## **PLAN REVIEW SHEET**

**Telephone:** 704-353-0018 **Petition:** 2014-059

Crosland LLC and Allen Tate Email: bhorton@charlottenc.gov
Attachments: Waiting Pad Detail

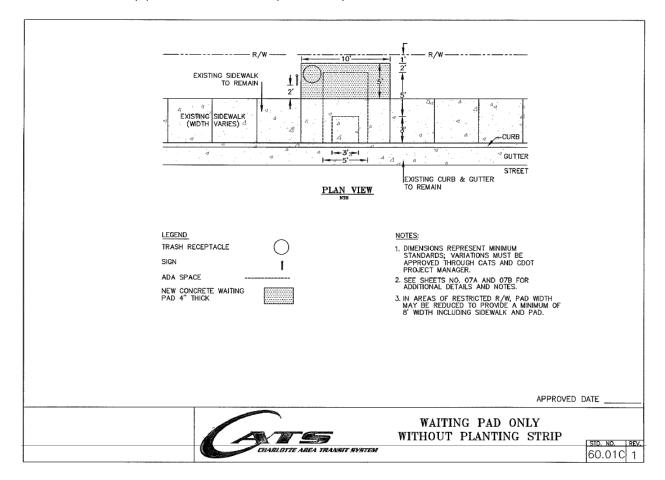
The Petitioner is requested to provide and construct a concrete waiting pad for a relocated bus stop along Sharon Road. If retaining the existing or constructing new sidewalk along the curb, the petitioner should use standard detail 60.01C. If new sidewalk is built away from the curb, or the proposed design changes, another standard detail may be more appropriate.

Below is an image of the standard detail (60.01C) for the requested bus stop pad. The site plan may either show the conceptual location of the improved bus stop on Sharon Road, or alternatively, include a development note to locate the bus stop pad during the development review and permitting process.
